SERVICE BULLETIN

M1450: Milwaukee-Eight Equipped Vehicles - Loss of Power or High Engine Braking

M1450

Figure 1. Cam Support Plate Tightening Sequence

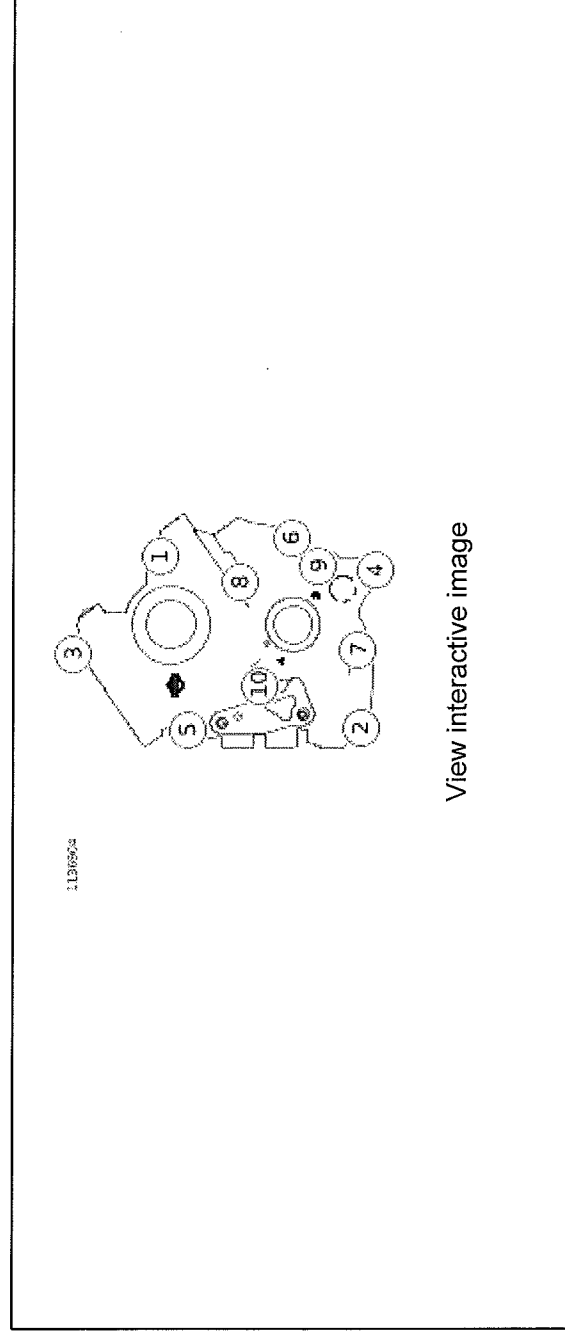
1. Install cam support plate. See the service manual.
2. **Refer to Figure 1.** Follow modified tightening sequence.

- a. Tighten screws 1–6.
- b. Rotate crankshaft 360°.
- c. Tighten screws 7–10.

Torque: 10.4–12.7 N·m (92–112 in-lbs)
